URGENT FIELD SAFETY NOTICE

GEHC Ref# 32076

RE: **Certain Giraffe Incubators and Giraffe OmniBeds – Oxygen sensor compatibility with Giraffe Systems**

Figure 4: Servo Oxygen software revision location

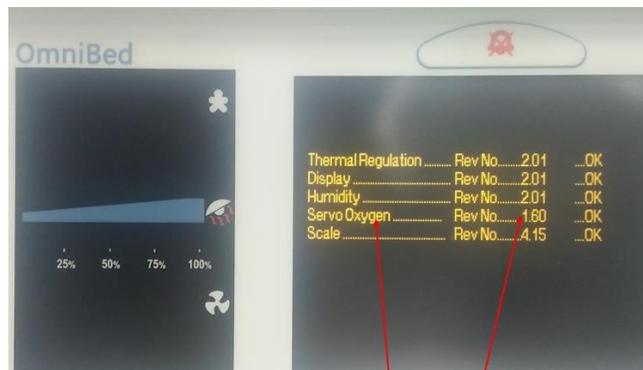
- a. If the Servo Oxygen module is NOT installed, (per Figure 3) **the device can be used, no further action.**
 - b. If the Servo Oxygen module is installed (per Figure 2), proceed to step 3.
3. Determine whether Servo Oxygen software revision needs to be checked:
 - a. If the 4th letter of the bed serial number (see Figure 1) is in the range from **A** through **M**, proceed to step 4.
 - b. If the 4th letter of the bed serial number (see Figure 1) is in the range of **N** through **Q**, turn the device power off and then back on and watch the screen to determine the Servo Oxygen software revision (see Figure 4). Note this screen will appear for 3 to 5 seconds.

- i. If the software revision identified is 1.60, **the device can be used, no further action.**
 - ii. If the software revision is 1.51 or lower, proceed to step 4.
4. Remove the oxygen sensor by following the instructions in the service manual to check the oxygen sensor part number. Refer to the Giraffe OmniBed service manual (P/N 6600-0343-000) Section 5.14.1 or Giraffe Incubator service manual (P/N 6600-0356-000) section 5.8.1 for instructions on how to remove the oxygen sensor. Note: Manuals can be downloaded from <http://customer-doc.cloud.gehealthcare.com/> (type manual P/N into search box)
